Our Case Number: ABP-317767-23

**Re: Proposed construction of 39 residential units, widening of Pausdeen Bridge and all associated site works.
Newtown/Ardclough Road, Newtown, Celbridge, Co. Kildare.**

Planning Observation Submissions to An Bord Pleanála

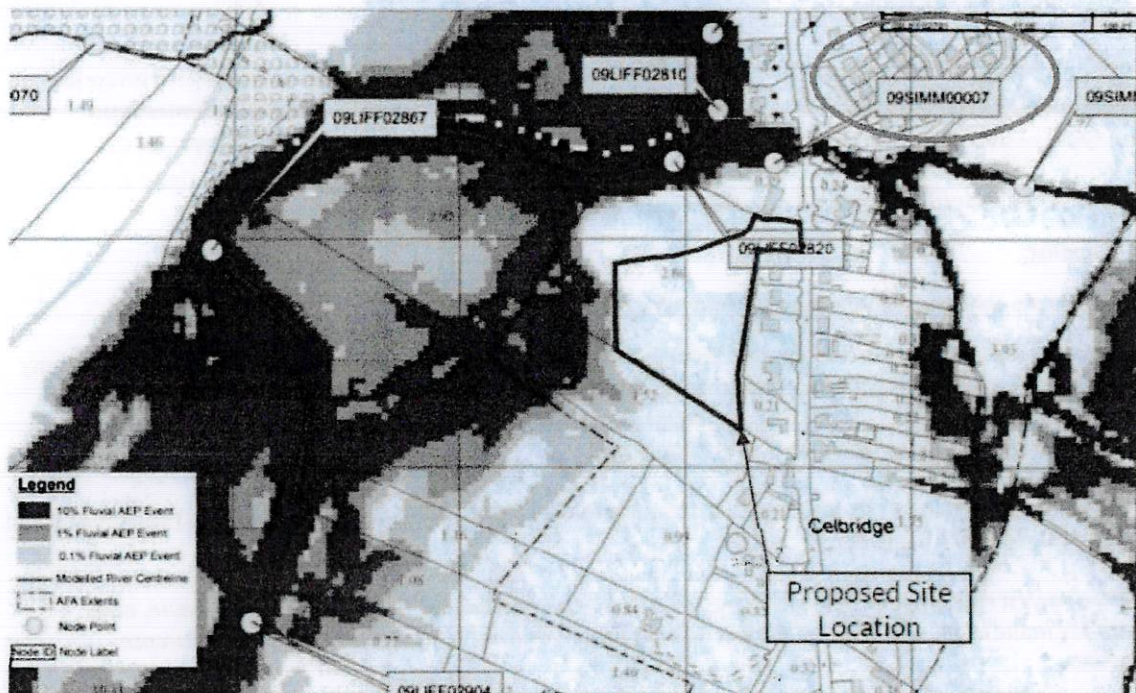
I have circled Chelmsford in green. The properties in the proposed site will not be able to obtain home insurance with flood cover included."

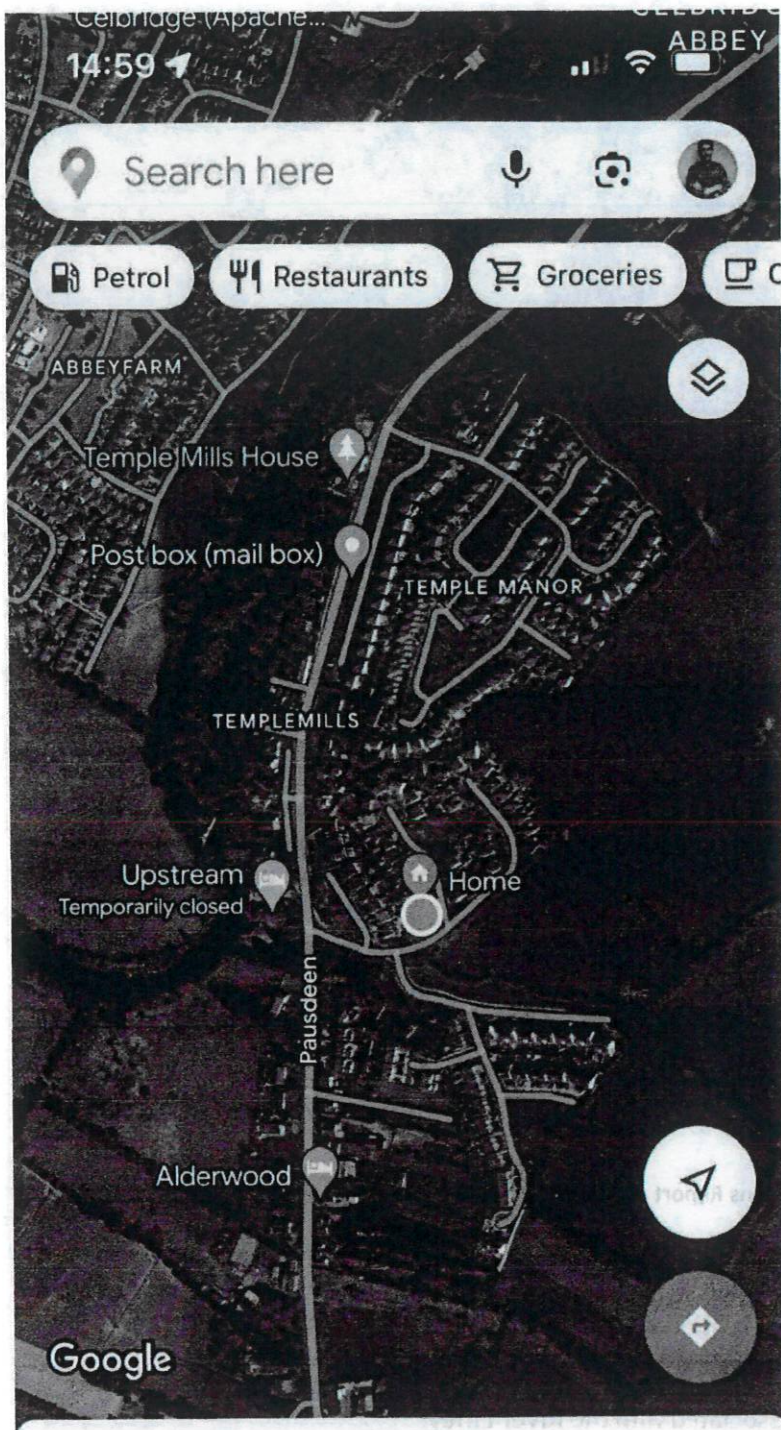
The flood report prepared by Tobin, states in section 1.4, that there are two future flood risk scenarios namely, the Mid-Range Future Scenario (MRFS) and the High-End Future Scenario (HEFS). The consultant chose to use the MRFS as the likely future scenario without having empirical data gathered from the site directly located in a flood plain. Why?

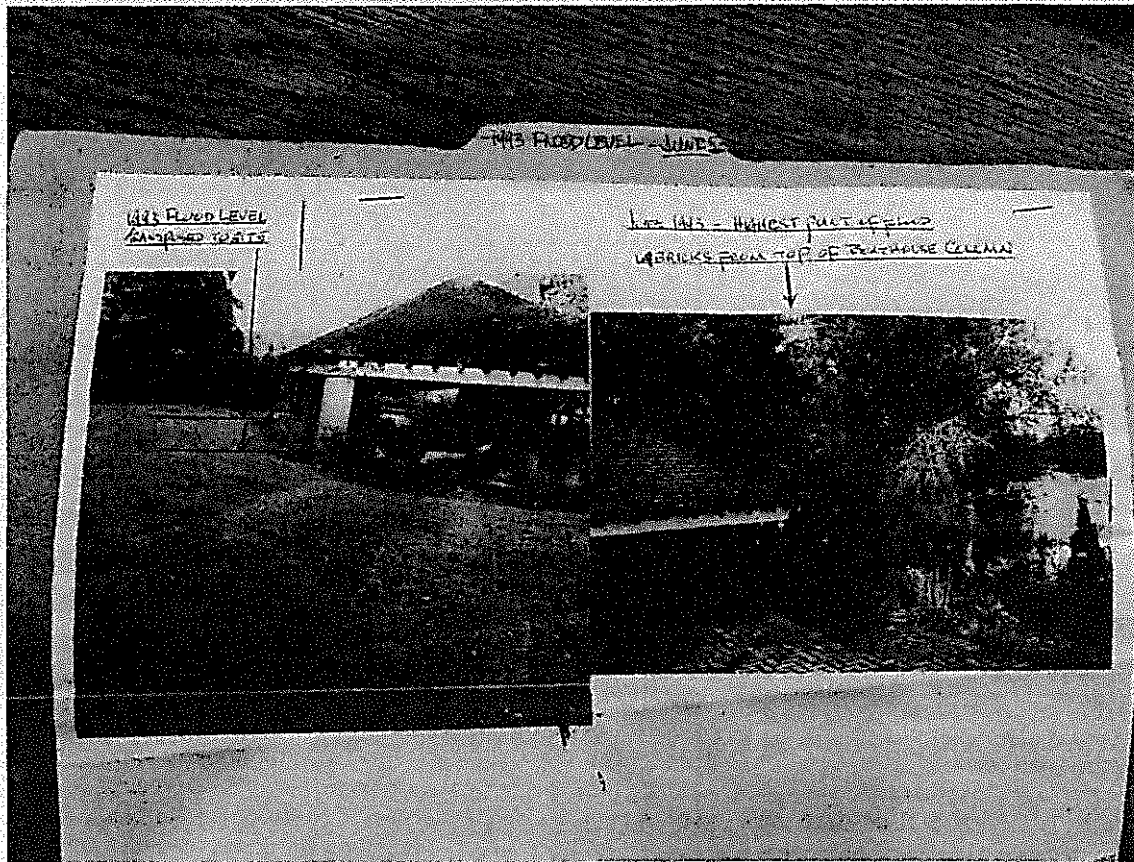
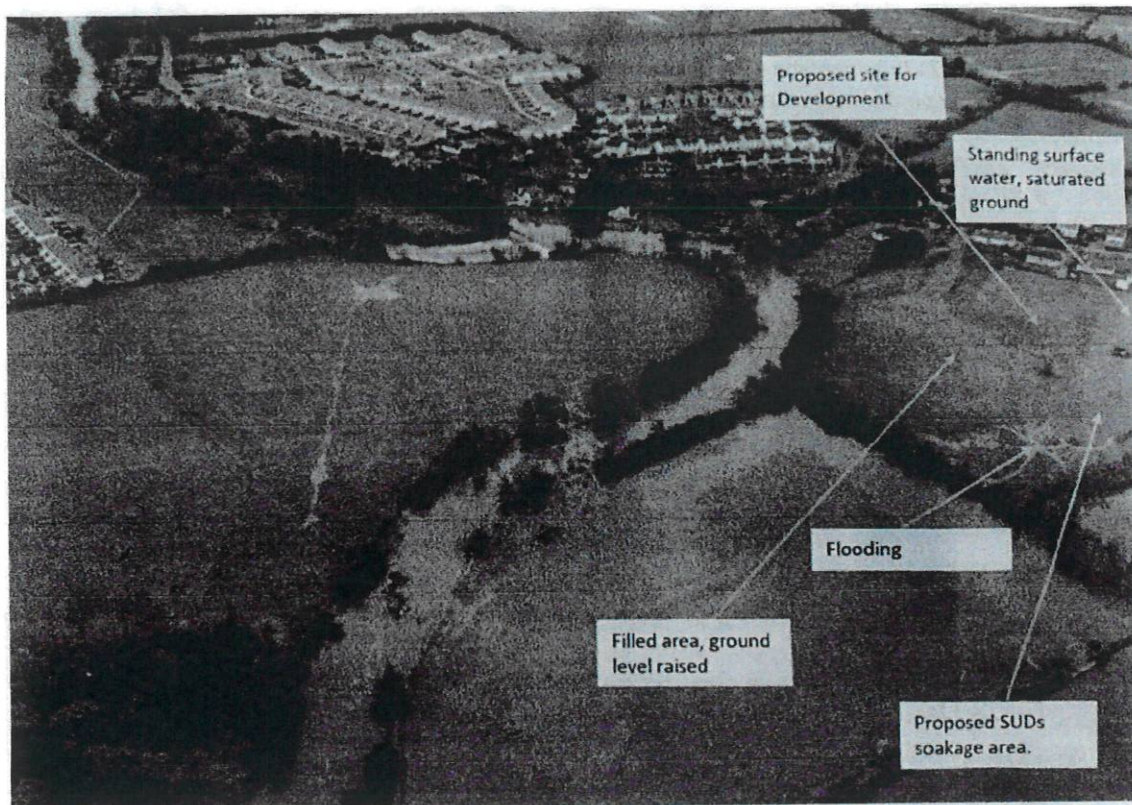
The diagram below shows that the site boundary (40m from river) would be the closest development to the flood plain on the west side of the Ardclough Road. No other development is as close to the Liffey flood zone on the southern side of the river.

Location: Drawing 210303-2-007 – Rev – VHA, Pedestrian Bridge

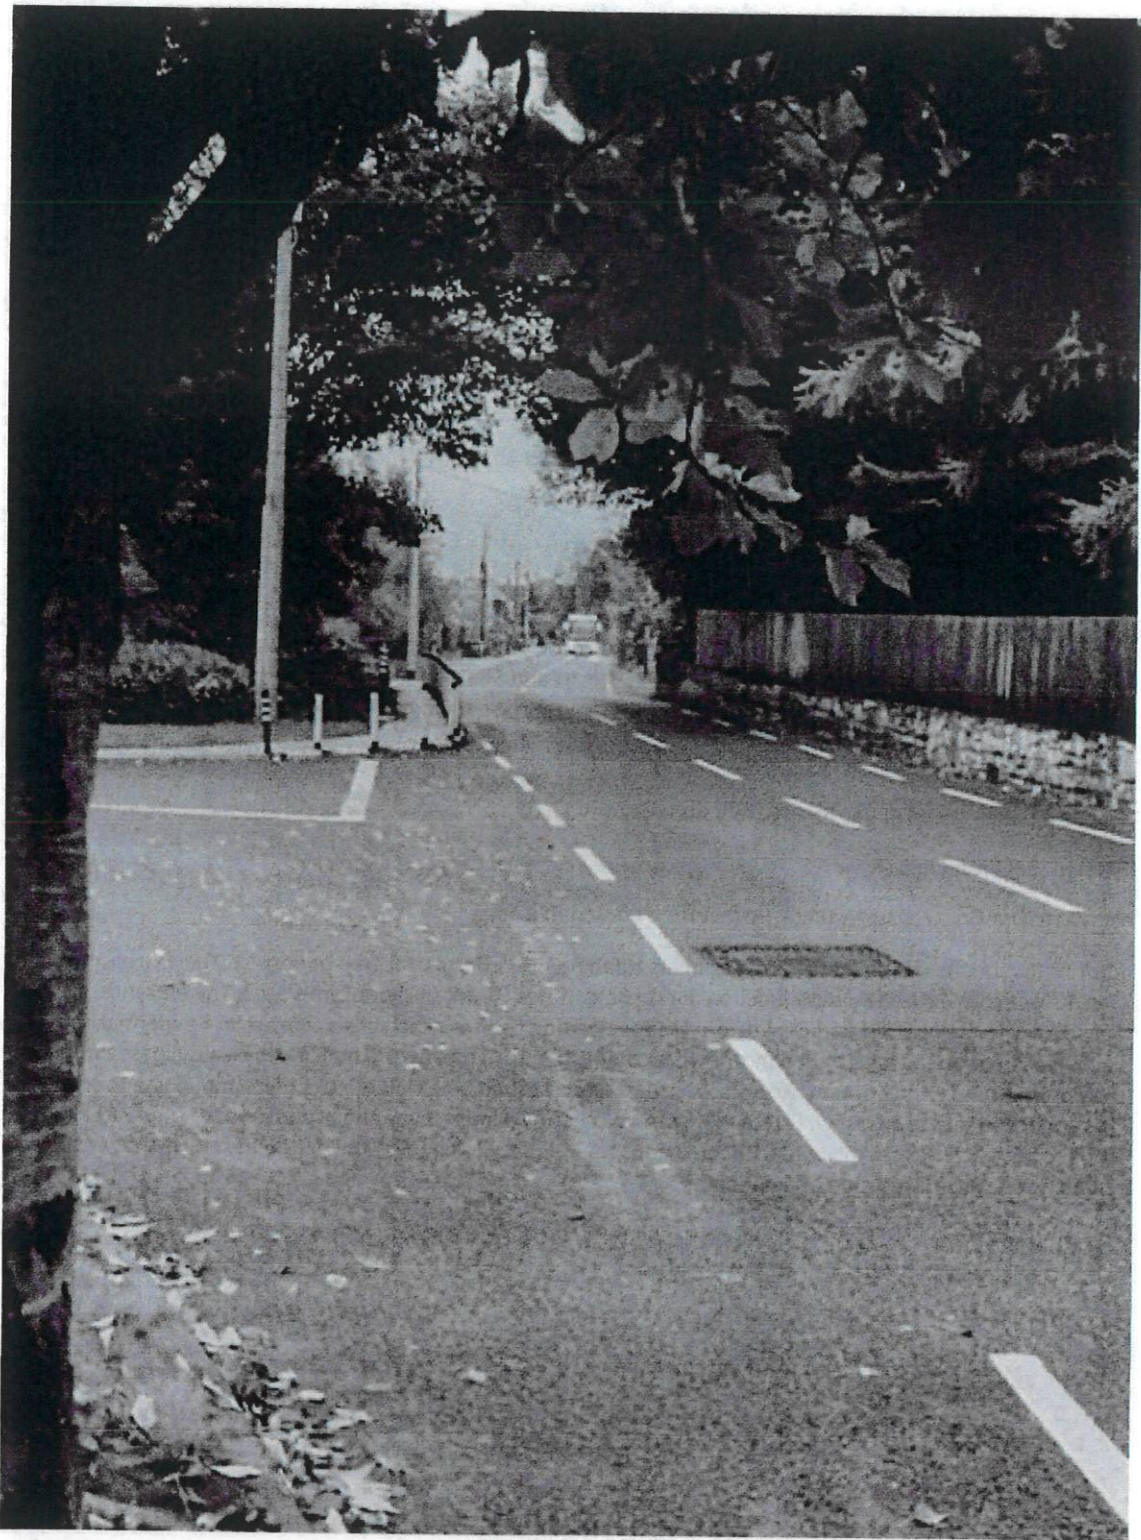
Information in the Bruton Consulting Engineers Road Safety report is not true or correct. The entrance at Chelmsford is an extremely busy junction during peak times (Work / School Times etc.). The entrance is the only access to Chelmsford and Chelmsford Manor Housing Estates which has a total of 95 Residential houses. Each house has an average of two motor vehicles which in turn means 190 motor vehicles can pass through the entrance at any one time. There is no dedicated bus stop for the children of Chelmsford going to school. This applies to the new Council Estate in Newtown recently acquired and the proposed site. There are no bus stop facilities at Simmonstown and Templemanor for children going to school on the bus. Note that cycling is not an option as there are no cycling routes.

Location: Drawing 210303-2-007 – Rev – VHA, Pedestrian Bridge

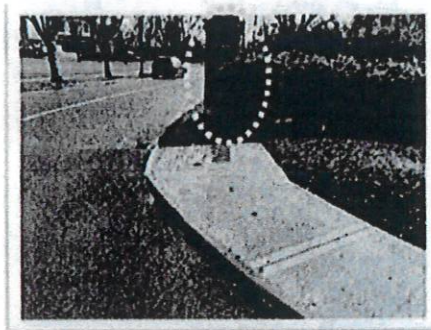
The information in the Bruton Consulting Engineering Report or KCC Planning Application Report does not consider the ownership of the Common Green Areas at Entrance along with the two Pillars at the entrance to Chelmsford. The lands are not owned by the County Council, and they will need permission from the owner to carry out any works on this proposed site.

Resolution: The Chelmsford Residents Association should be given documented evidence that permission from the owner that any works on the planning application for bridge widening and new proposed zebra crossing has been given.
